City of El Paso – City Plan Commission Staff Report

Case No: SUSU14-00023 – Kern View Estates Unit Two Replat A
Application Type: Resubdivision Combination
CPC Hearing Date: November 6, 2014
Staff Planner: Nelson Ortiz, (915) 212-1606, ortiznx@elpasotexas.gov
Location: East of Stanton and North of San Mateo
Acreage: 15.5757 acres
Rep District: 1
Existing Use: Vacant
Existing Zoning: R-3 / P-R 1/c (Residential / Planned Residential/condition)
Proposed Zoning: R-3 / P-R 1/c (Residential / Planned Residential/condition)
Nearest Park: Mission Hills Park (.23 mile)
Nearest School: Mesita Elementary School (.70 mile)
Park Fees Required: \$83,570.00
Impact Fee Area: N/A
Property Owner: Piedmont Group, LLC
Applicant: Piedmont Group, LLC
Representative: Brock & Bustillos, Inc.

ATTACHMENT 3

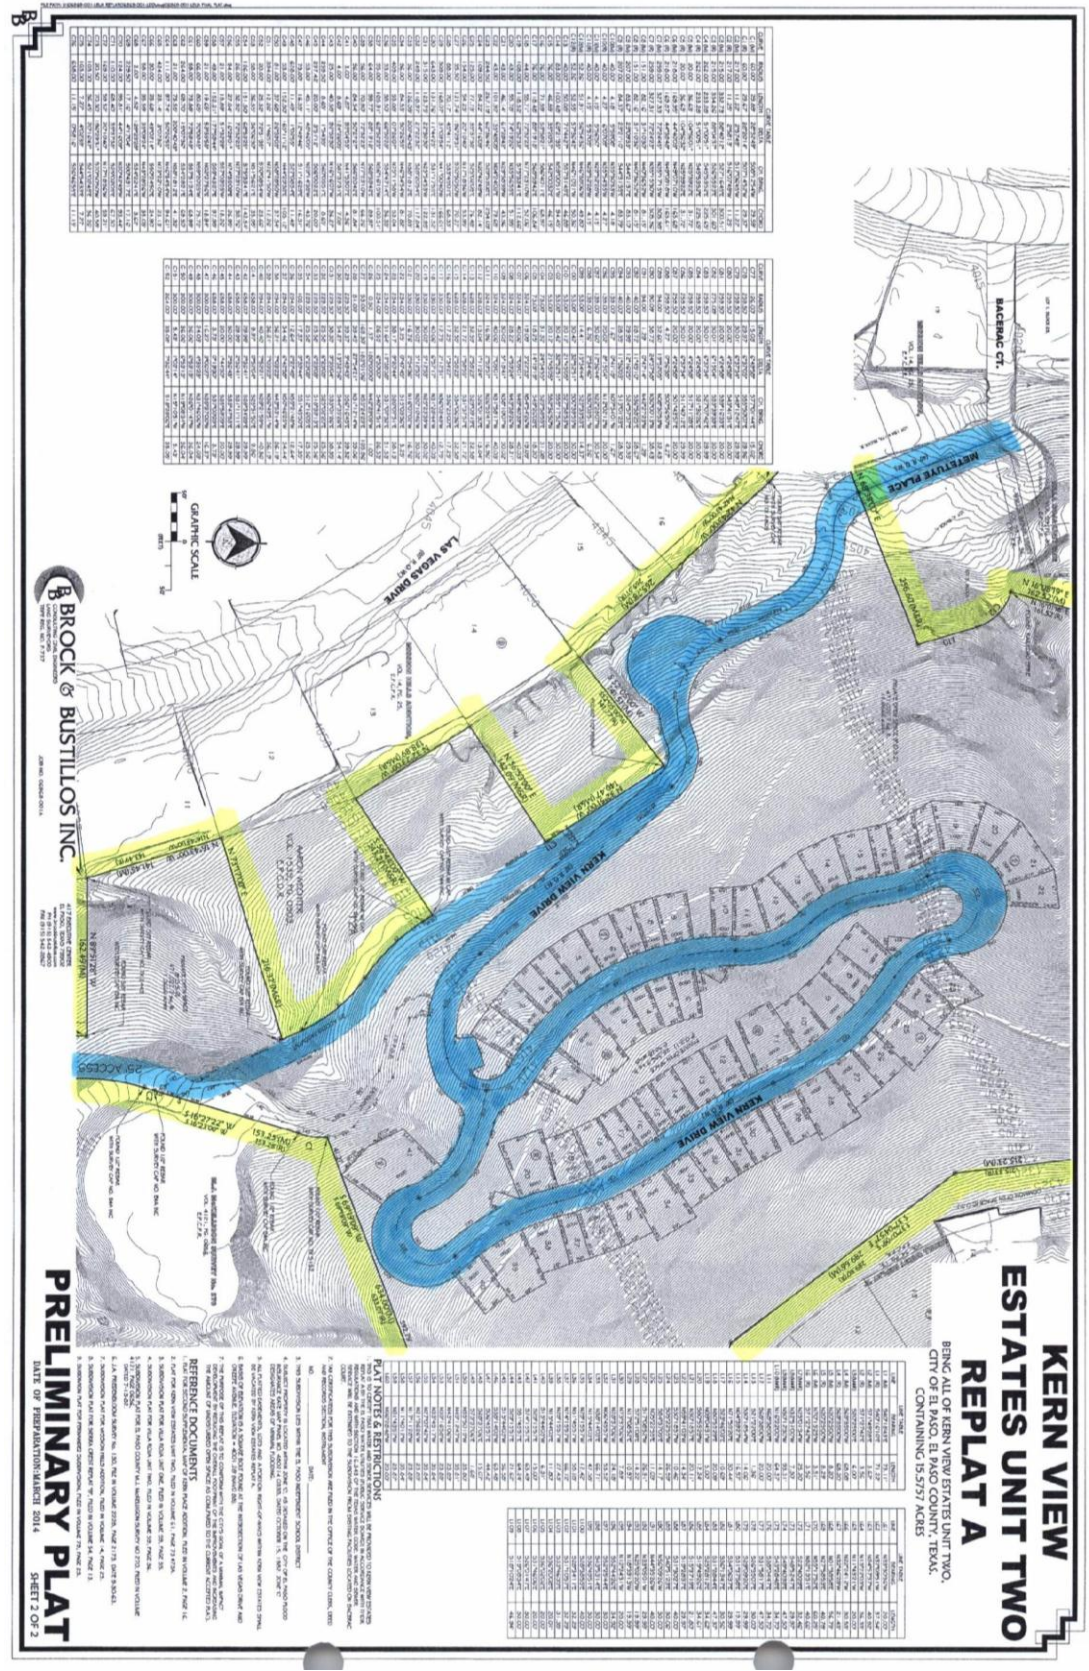
1. Verify line of sight for proposed monuments along drives.
2. On the street cross-sections, need to label the slope and direction.
3. Provide cross section for proposed future private Piedmont Drive.
4. Show proposed drainage flow patterns and contours on the preliminary plat. Identify the discharge location for all storm-water runoff.
5. Verify safe conveyance of the existing watercourse through the developed subdivision and show that all downstream storm-water management facilities have sufficient capacity to carry the additional runoff.

6. Provide a note on the plat indicating the entity responsible for maintenance of private drainage easement and private open space.

- Addressing shall be displayed on the plat.
